# Hill Head Coastal Defence

Independent Review Guard Rail

Fareham Borough Council

July 2017

**Figure 1:** Cross-section through the Seawall (Source – ARUP, 2017)

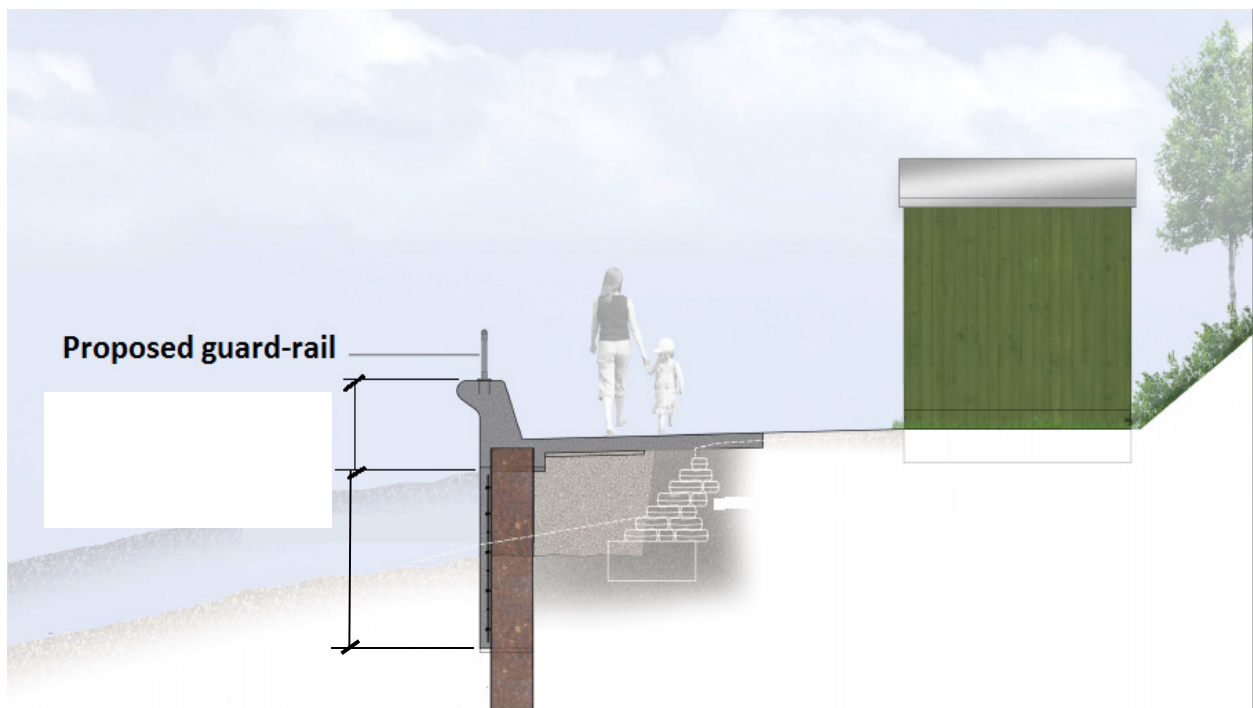
The proposed new footpath level has been maintained at +3.0m AOD for consistency with existing structures at both ends of the works. The purpose of the Seawall is to protect the coast behind and the level of the concrete upstand was calculated using wave height information with future sea level rise accounted for. The level of the beach means that at some points along the Seawall there is a potential falling distance of 2.76m (ARUP, 2017). It is likely that any person falling such a distance will suffer injury and probably serious injury.

Given what is set out above, it is our opinion that there is no supportable (or logical) argument for providing a lower level of protection for people using the public promenade behind the Seawall than for those using public buildings, meaning that in order to comply with the more onerous Building Regulations, the height of the edge protection; Seawall plus guard-rail, should be 1100 mm.

Therefore, it is our opinion that the Designer was correct to provide a guard-rail on top of the Seawall, to a level of 1100 mm above the ground (Promenade) behind the Seawall.

**Figure 3:** Illustrating recommended measure for further reduction of foothold on the Seawall

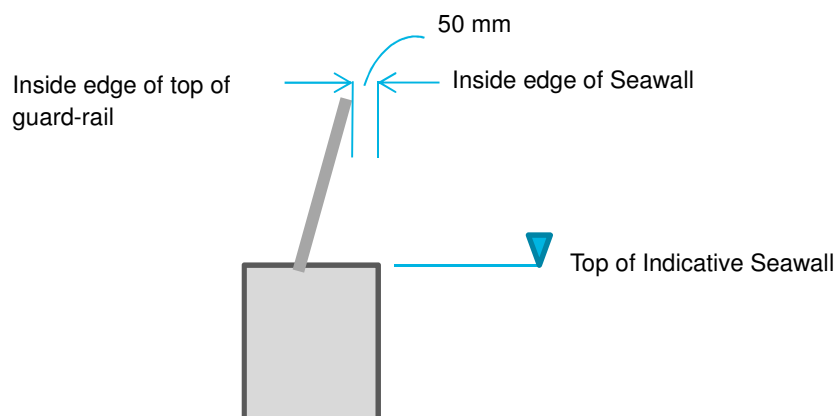
However, it is our opinion that 200 mm would still allow a person to stand on the Seawall, with most of his/her feet on the Seawall. Therefore, to provide a more assured deterrence to climbing the Seawall, it is our opinion that the guard-rail should lean inwards to create less space for a foothold on the top of the Seawall; Figure 2(c) illustrates this principle.

The 200 mm space between the guard-rail and the inside of the Seawall may not be the deterrent that the designer hoped for because it will allow a foothold on the top of the Seawall. There may be structural reasons for the provision of 200 mm, which we are not in a position to challenge. Therefore, to provide further discouragement against climbing the Seawall, we would recommend that the guard-rail is leant inwards to a point where its principal guard-rail is 50 mm off the edge of the Seawall [Figure 3].

Figure 1: Cross Section through structure showing design beach levels

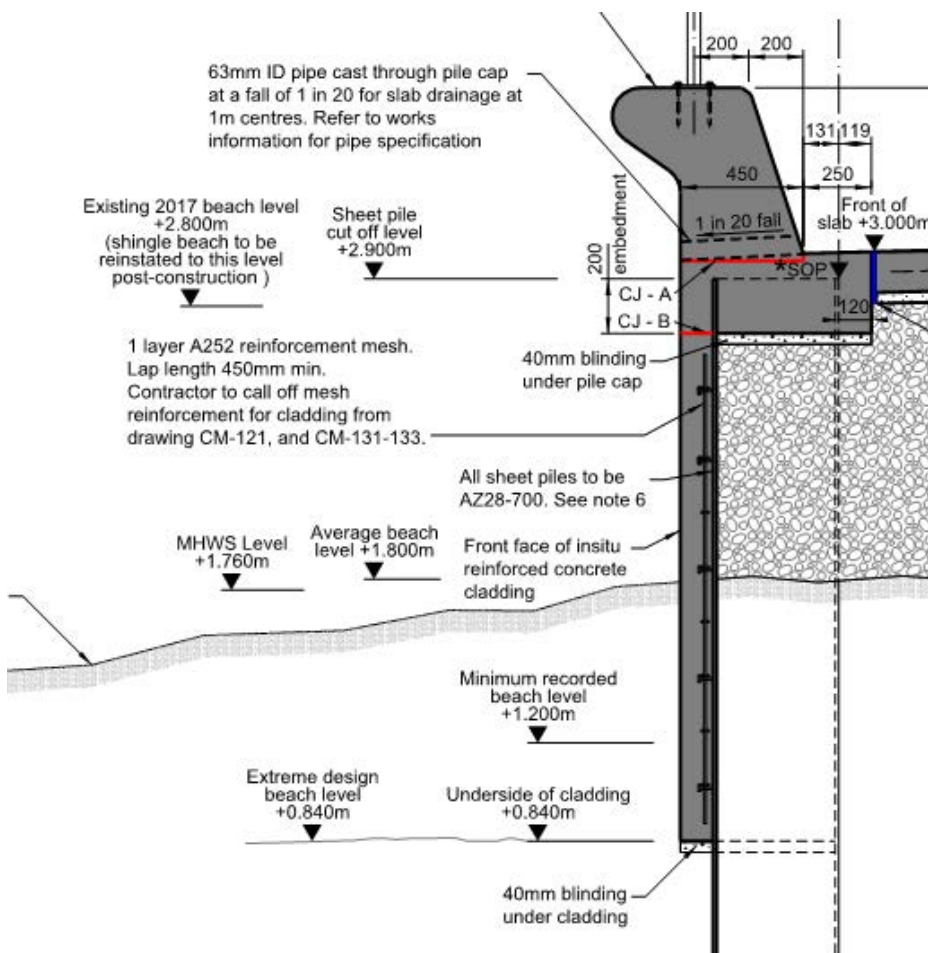
The design levels for the beach (shown below in Figure 1) were calculated based on seasonal lowering of beach material and localised scour at the toe of the new sheet pile wall. This takes into account the possibility that ESCP may not necessarily maintain the current beach levels in the future. As this is a new structure, it is necessary to consult health and safety regulations on the provision of barrier rails. The drop from the top of the upstand to the extreme design beach level is 2.76m, which is large enough to justify the specification of a barrier rail.

The risk assessment has considered a fall from the top of the upstand wall – a level of +3.6m AOD. This is due to the importance of the upstand wall as part of the design for providing protection from overtopping and flooding over the 50 year design life. The design level took into consideration storm surge levels and likelihoods as well as expected future sea level rise within the design life.

Yes – following the building regulations a total barrier height of 1100mm from walkway level is required, thus 500mm from the top of the upstand wall, and therefore a full 1100mm of barrier rail would be designed if the upstand wall was not required.
